Unit D North Bank Road, Port Talbot

Transport Note

Document Reference: **C24120/TN01**

- 1.1.1 Apex Transport Planning (“Apex TP”) has prepared this Transport Note (TN) to provide further information in response to comments provided by the highway authority, Neath Port Talbot County Borough Council (NPTCBC), in relation to the planning application (reference: P2024/0212). The application is for the construction of industrial unit comprising 4 no. self-contained units, with unit 1-2 operating as a class 7 MOT centre for vans and cars, and units 3-5 for B2 or B8 use class, on land off North Bank Road, Port Talbot, SA13 1RE.

PROJECT NO. C24-120	SCALE @ A3 1:250
STATUS DESCRIPTION INFORMATION	STATUS S2
DRAWING NO. C24120-ATP-DR-TP-0002

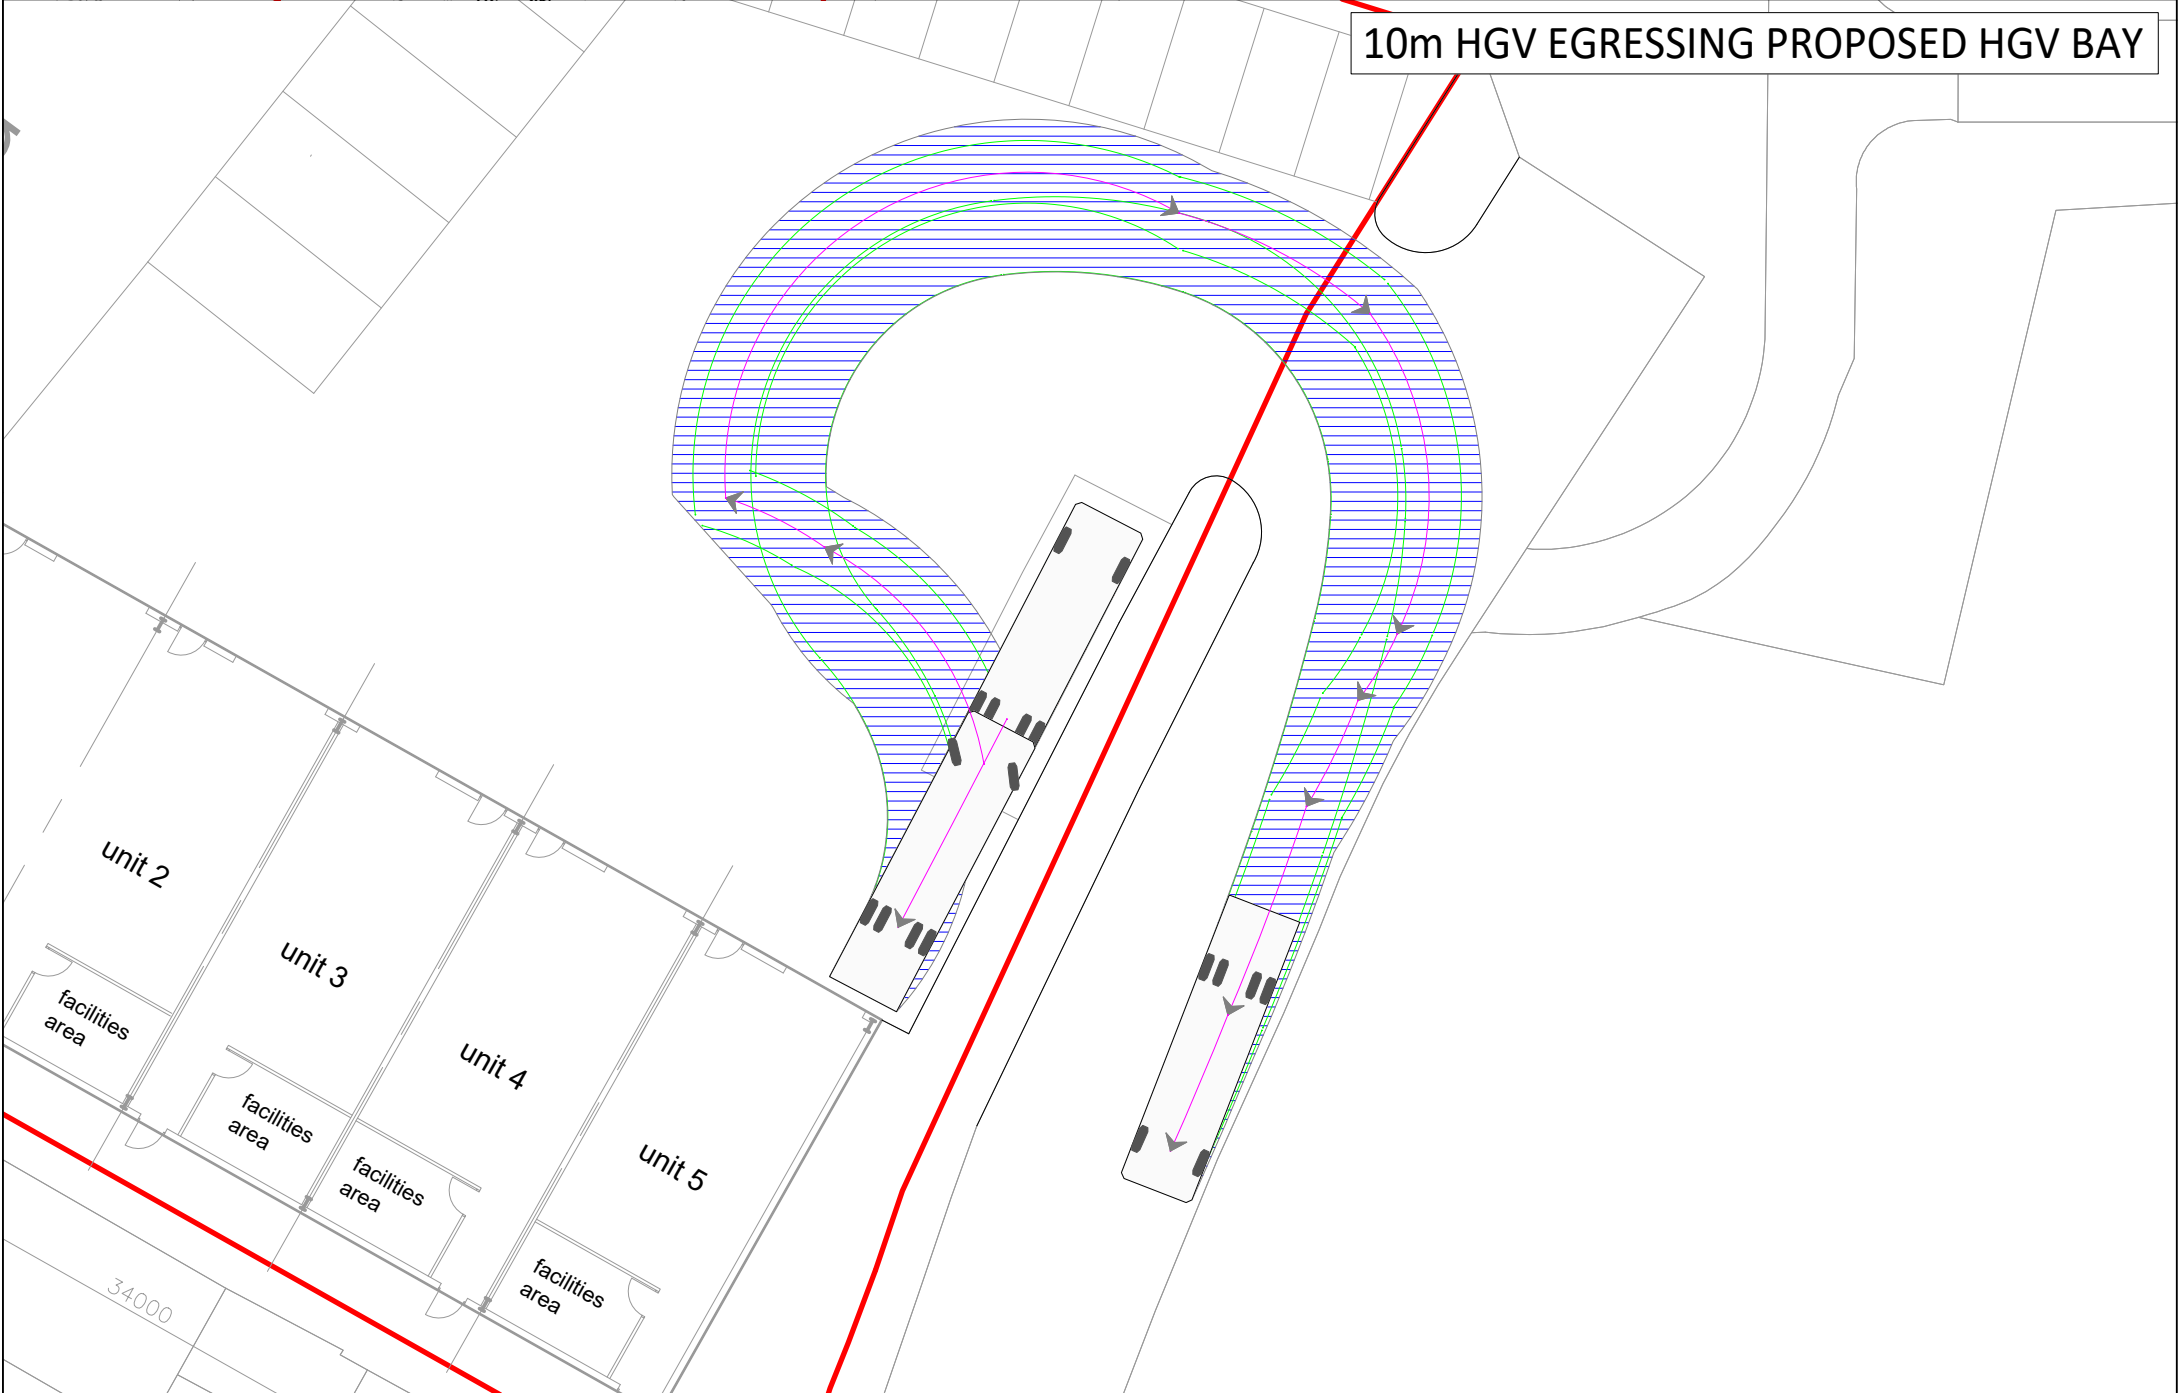
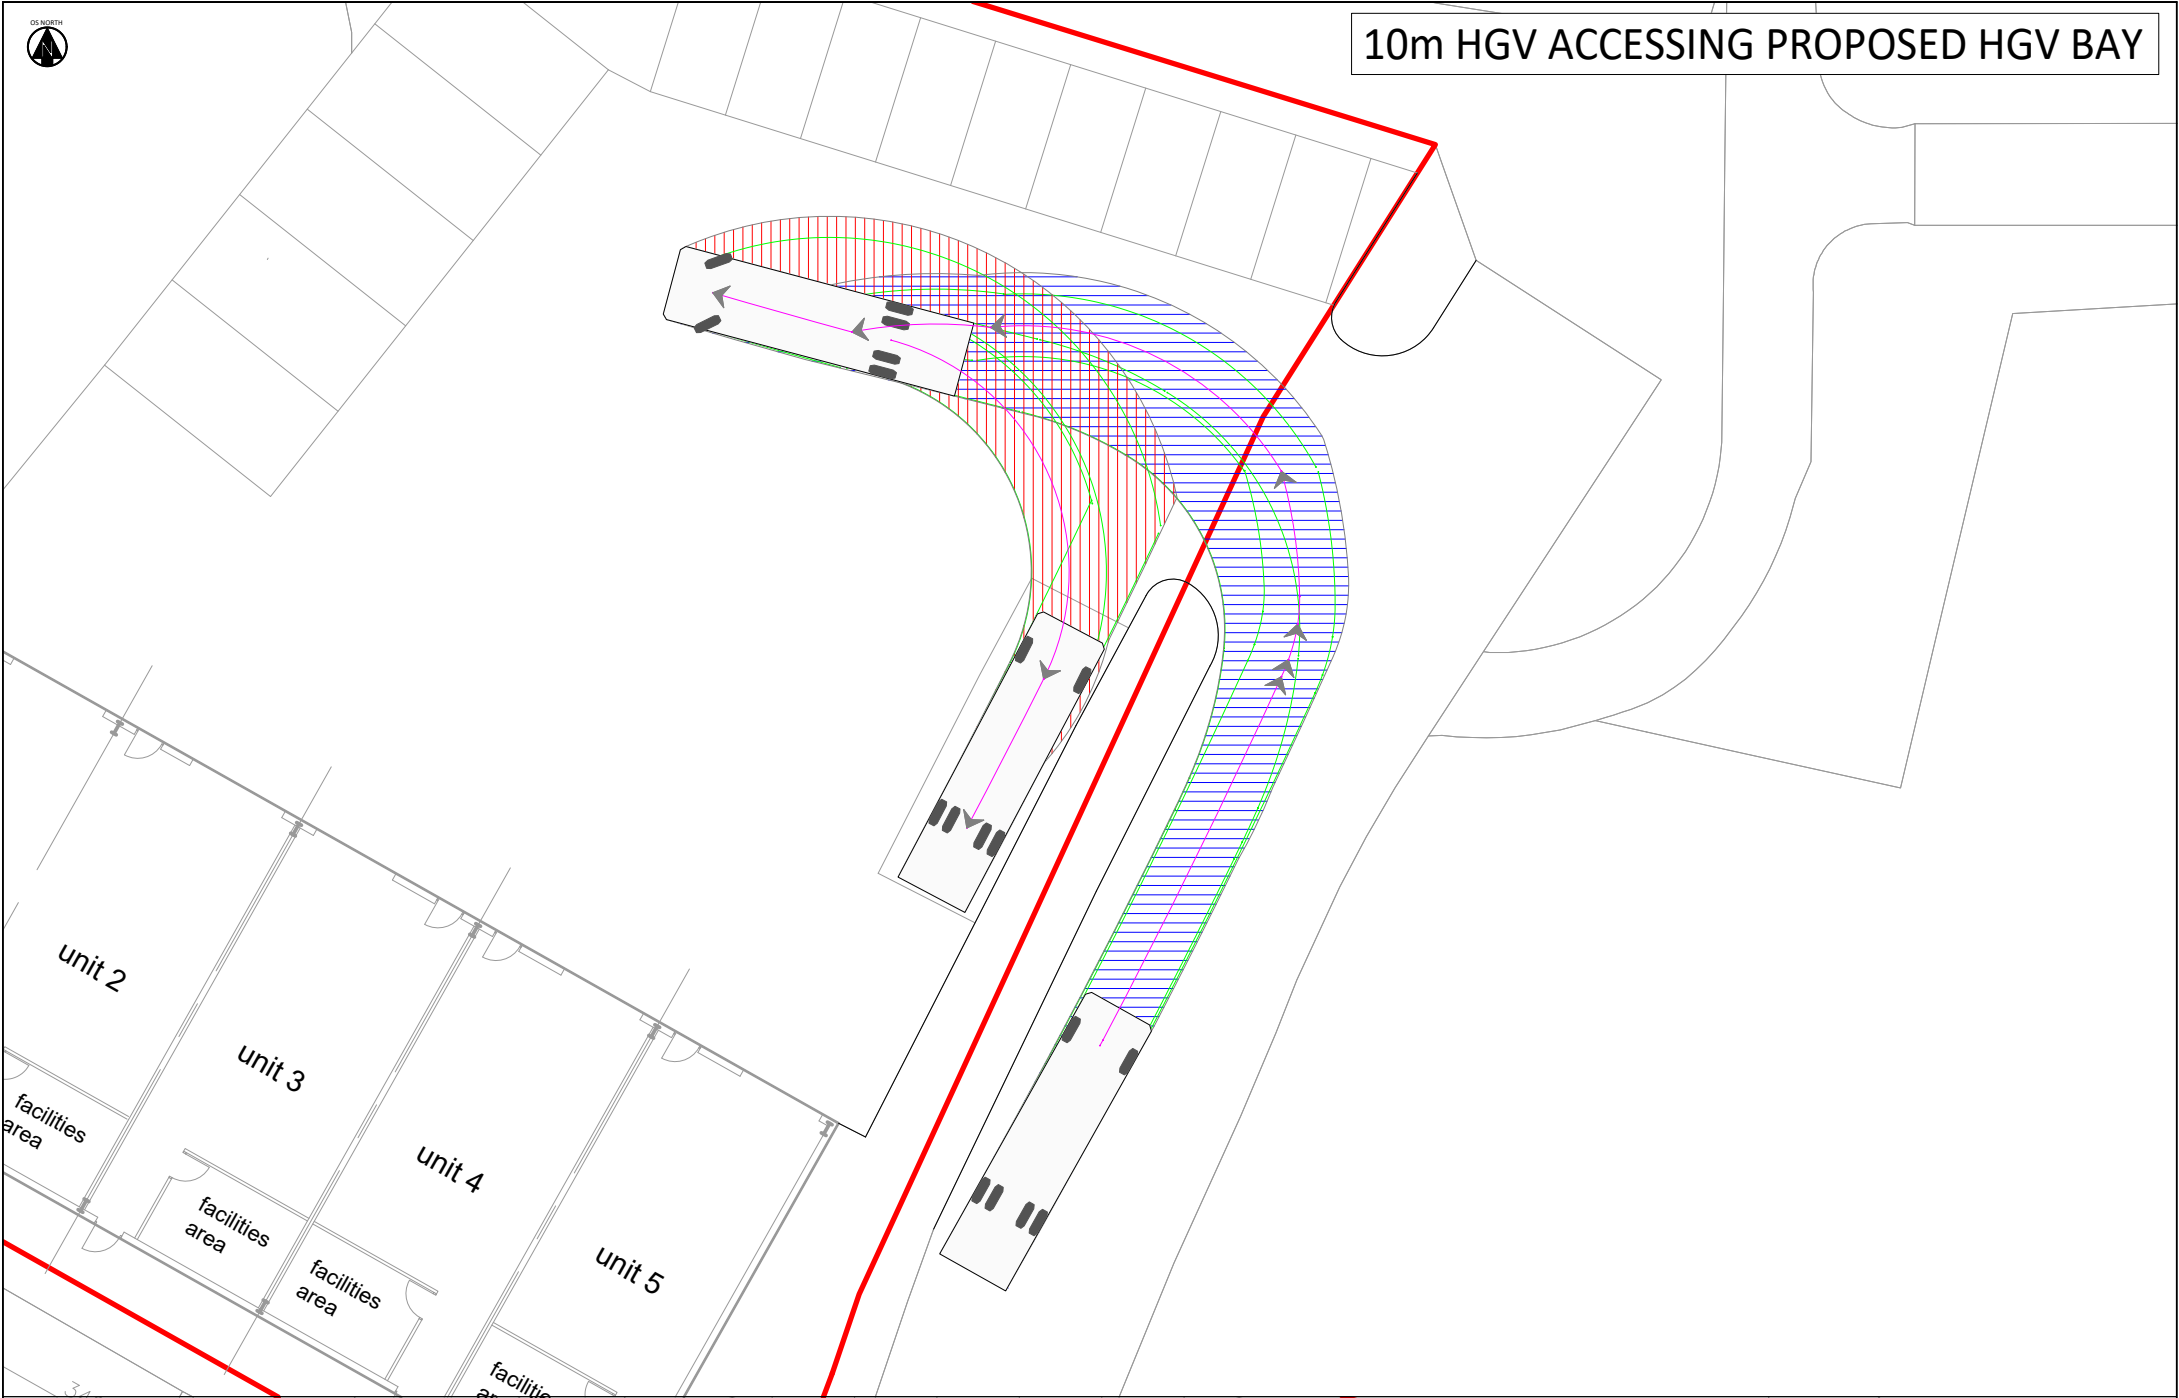
“What is the largest vehicle that will service the development?”

- 3.1.1 The applicant has confirmed that the maximum vehicle will be a LGV (up to 3,500 kg).

- 3.1.2 Swept path analysis has been undertaken demonstrating that a LGV (shown as a large panel van) can access the units. The swept path analysis drawing is attached at Appendix D.

PROJECT NO. C24-120	SCALE @ A3 1:250
STATUS DESCRIPTION INFORMATION	
DRAWING NO. C24120-ATP-DR-TP-0003

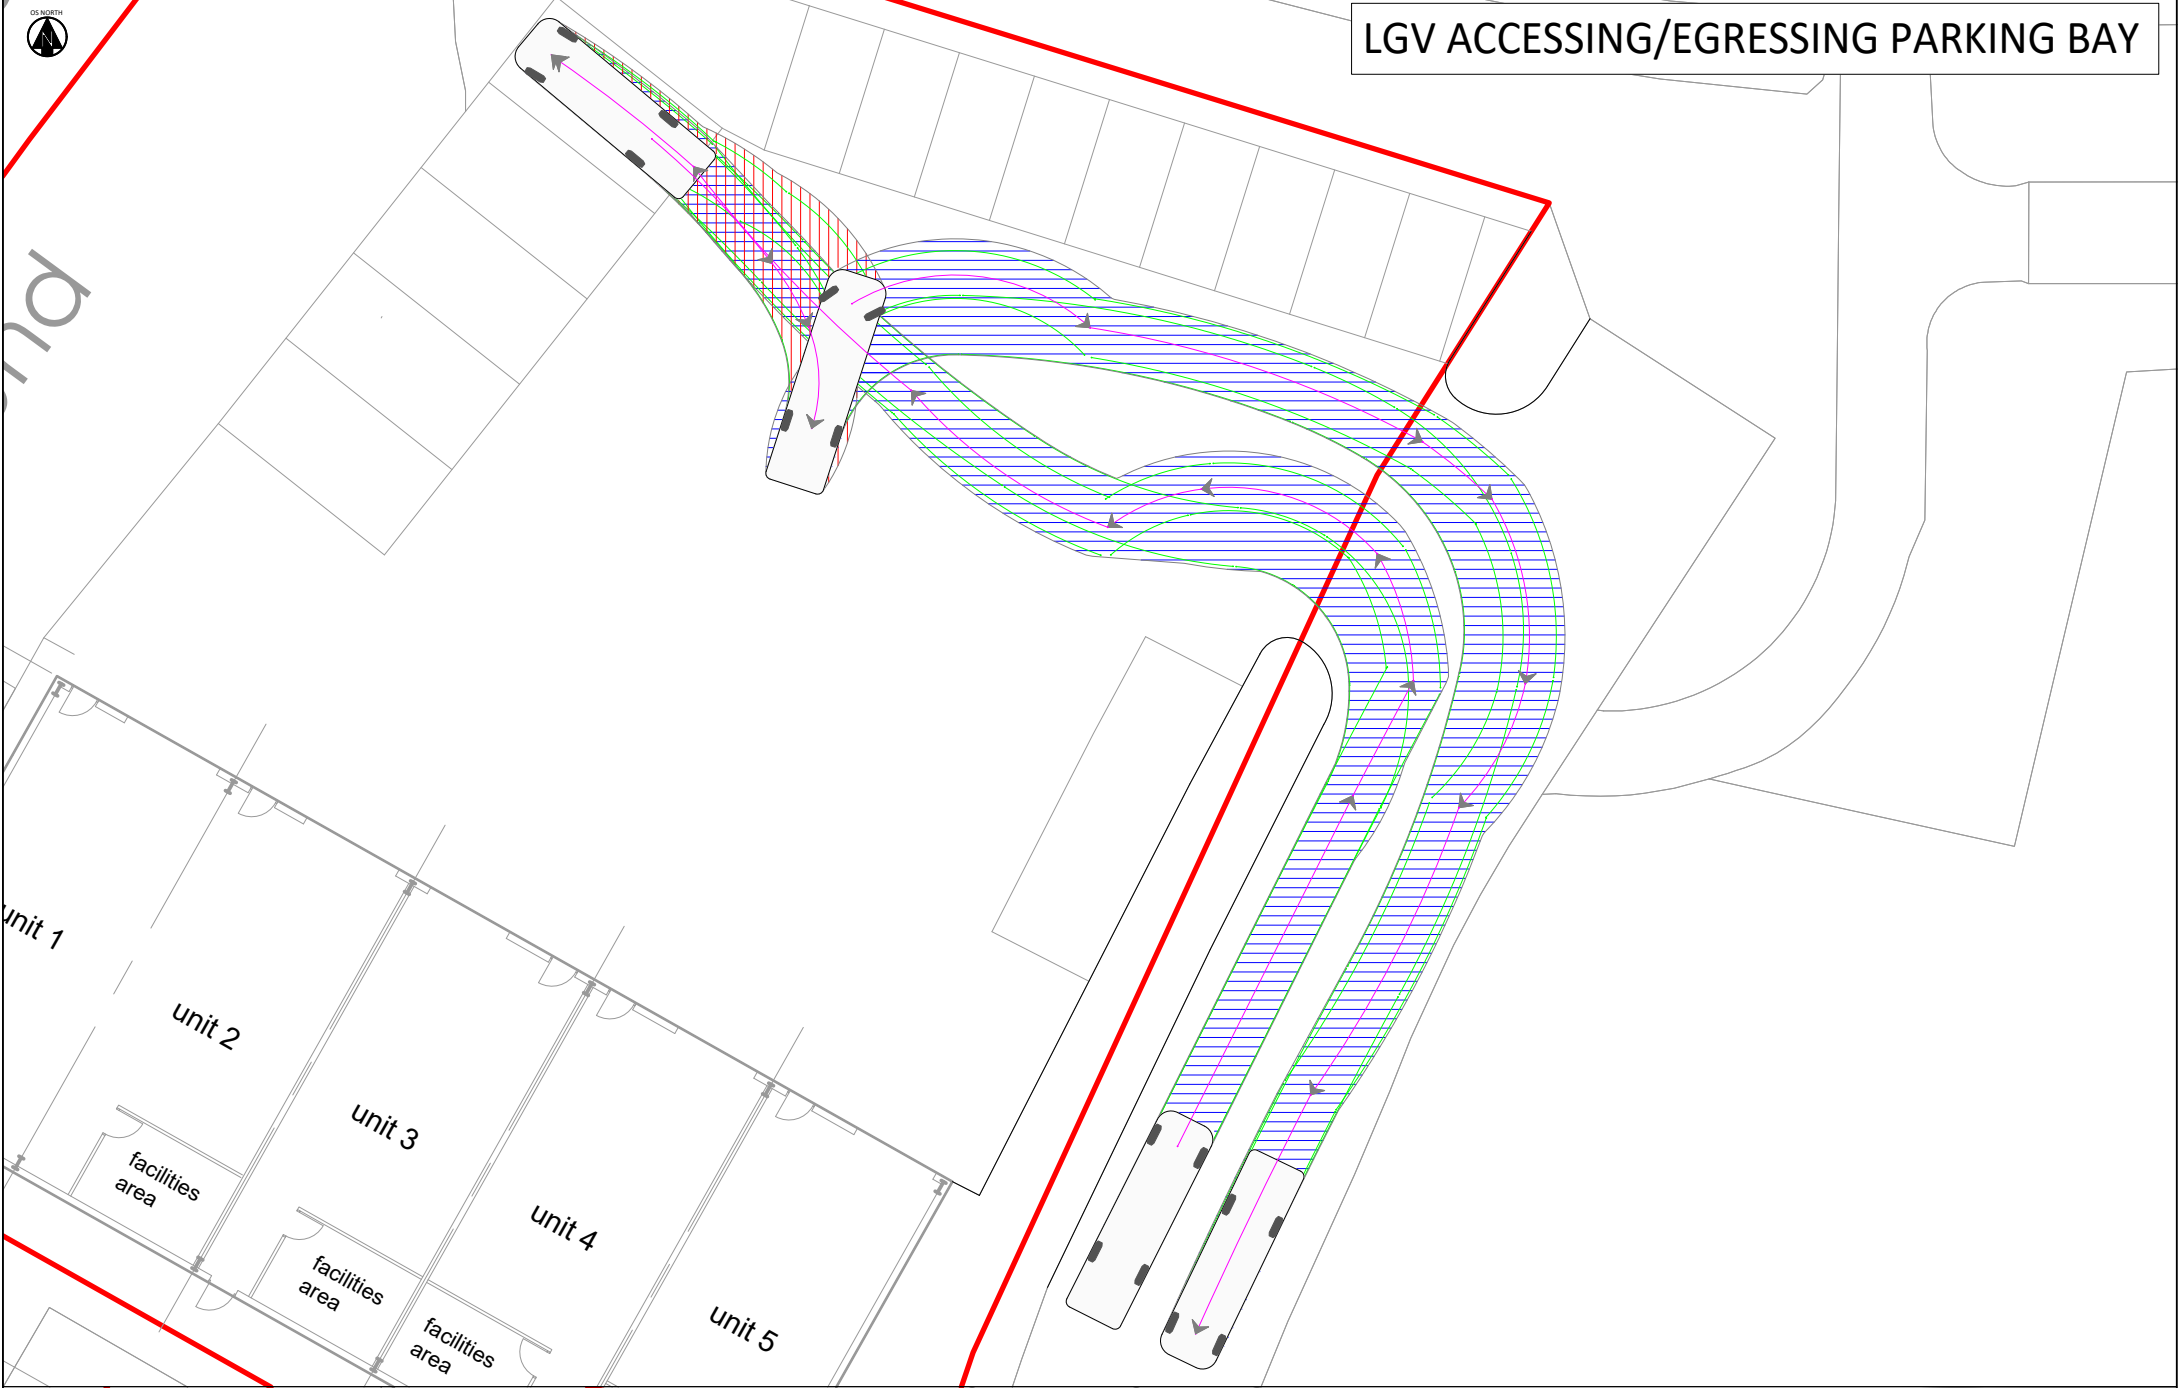
“Parking for the M.O.T centre element should be 1 lorry space (with 20% of the GFA of the M.O.T centre around it for loading/unloading) and 2 car/LGV spaces per service bay in accordance with our SPG Parking Standards (Oct 16).”

- 5.1.1 The revised layout demonstrates the provision of one HGV space, in line with the parking standards, to accommodate a maximum vehicle size of 10m in length. However, it is unlikely that a HGV will be required to access the site, as the largest vehicle size as informed by the applicant would be a light goods vehicle of up to 3,500 kg. Swept path analysis demonstrating a 10m HGV accessing/egressing the site and the HGV parking bay is shown at Appendix E.
